Re: Event Hall

900 Old Coors Dr. SW Traffic Circulation Layout Architect's Stamp 05-05-23 (L11-D070)

Based upon the information provided in your submittal received 05-23-23, the above referenced plan cannot be approved for Building Permit until the following comments are addressed:

TCL1.0

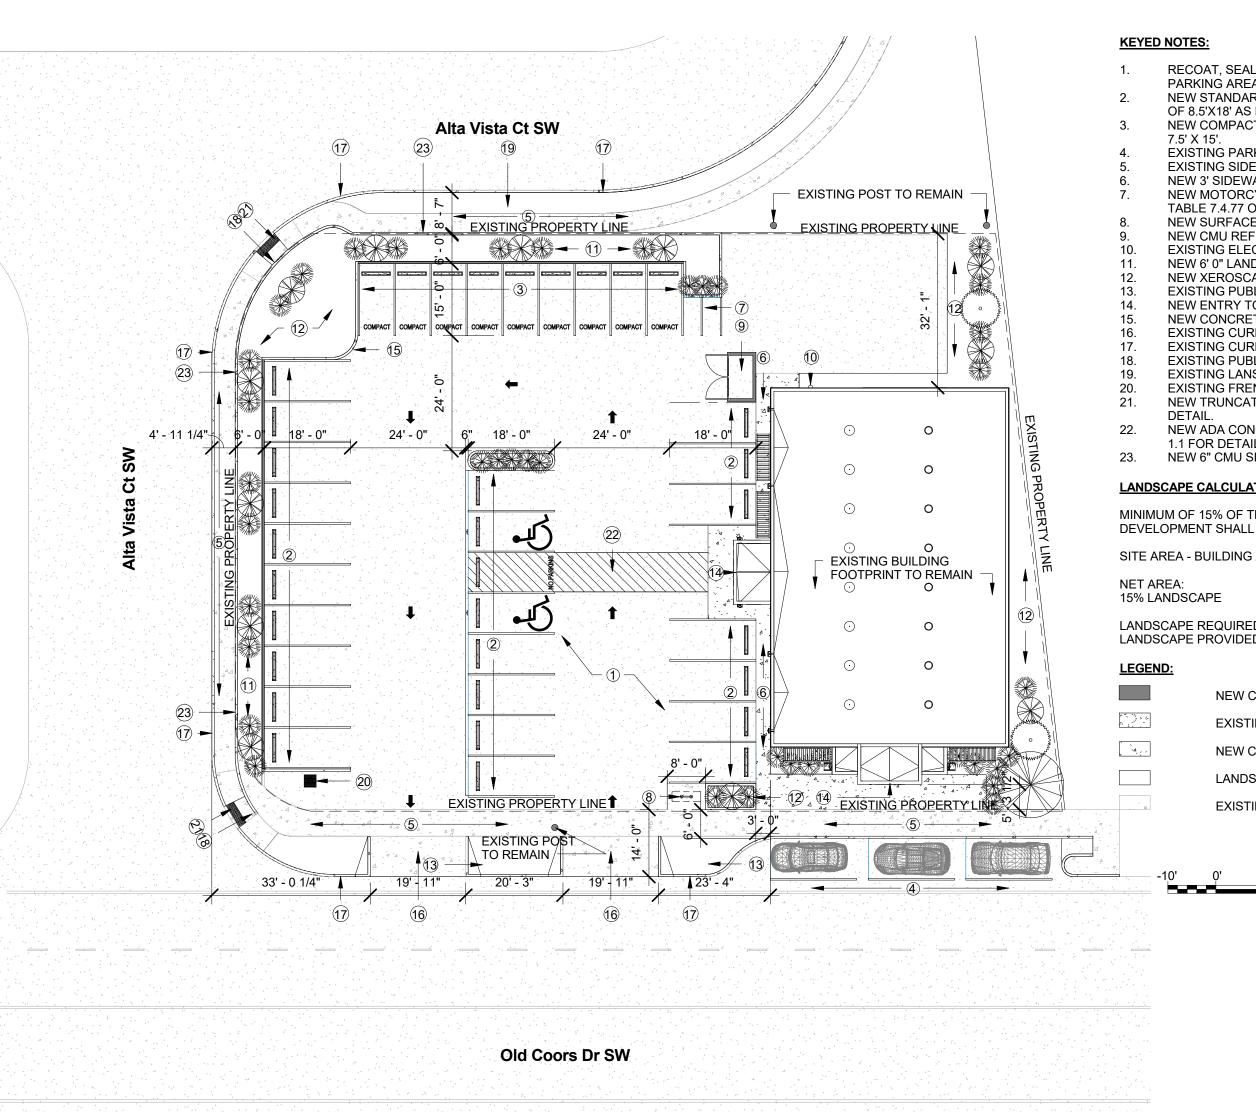
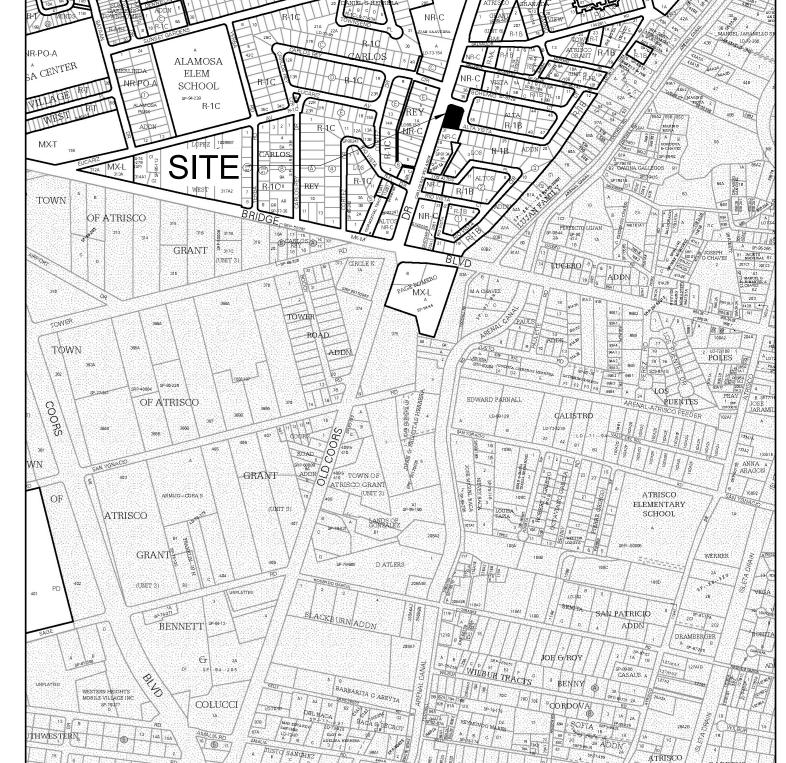
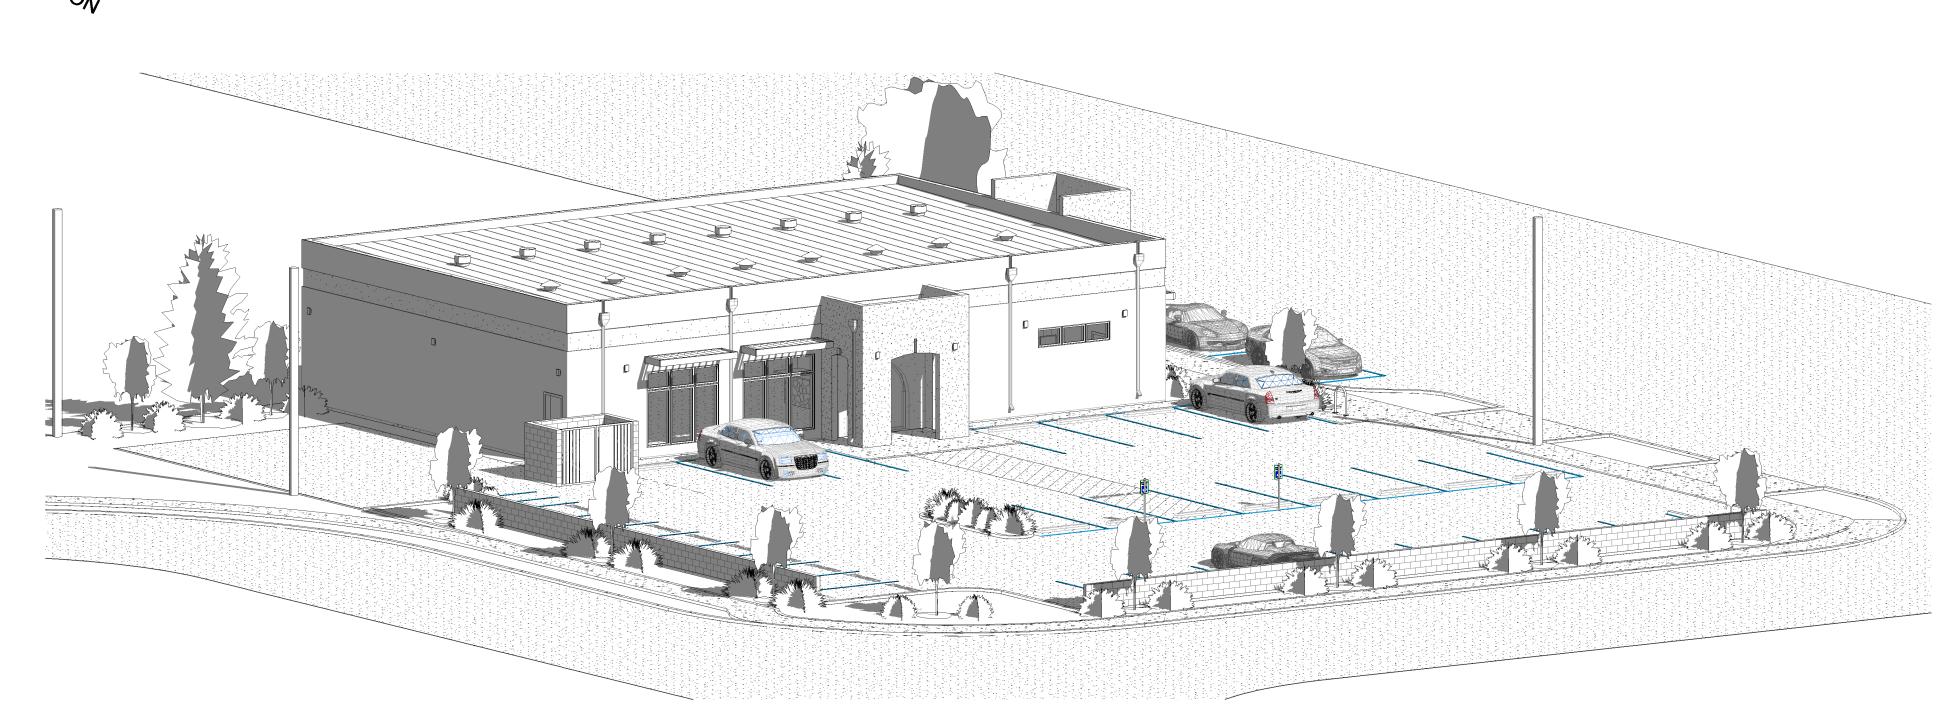
- 1. List the number of Bicycle parking spaces required by the IDO.
- 2. Identify all existing access easements and rights of way width dimensions.
- 3. Identify the right of way width, medians, curb cuts, and street widths on Old Coors Dr. and Alta Vista Ct.
- 4. The minimum distance from the site access to the intersection is 100 ft. so, the north side site access must be closed and replaced with sidewalk and curb & gutter. A build note must be provided referring to the appropriate City Standard drawing 2430.

- 5. South side site access must be a minimum 22 ft. wide to serve two-way traffic.
 - 6. A minimum 4-foot wide pedestrian path should be shown around the pole; show this dimension on the site plan to ensure that a minimum 4-foot wide path is obtained.

7. Please clarify, is this ADA pathway flush or an ADA ramp will be provided?

- 8. Per the IDO, a 6 ft. wide ADA accessible pedestrian pathway is required from the public sidewalk to the building entrances. Please clearly show this pathway and provide details.

- 9. Refuse vehicle maneuvering shall be contained on-site. The refuse vehicle shall not back into the public right of way.; provide a copy of refuse approval.

- 10. Provide a copy of Fire Marshall approval.
- 11. Show the clear sight triangle and add the following note to the plan: "Landscaping and signage will not interfere with clear sight requirements. Therefore, signs, walls, trees, and shrubbery between 3 and 8 feet tall (as measured from the gutter pan) will not be acceptable in the clear sight triangle.

- 12. Please specify the City Standard Drawing Number when applicable.
- 13. Add a note stating "All broken or cracked sidewalk must be replaced with sidewalk and curb & gutter." A build note must be provided referring to the appropriate City Standard drawing.
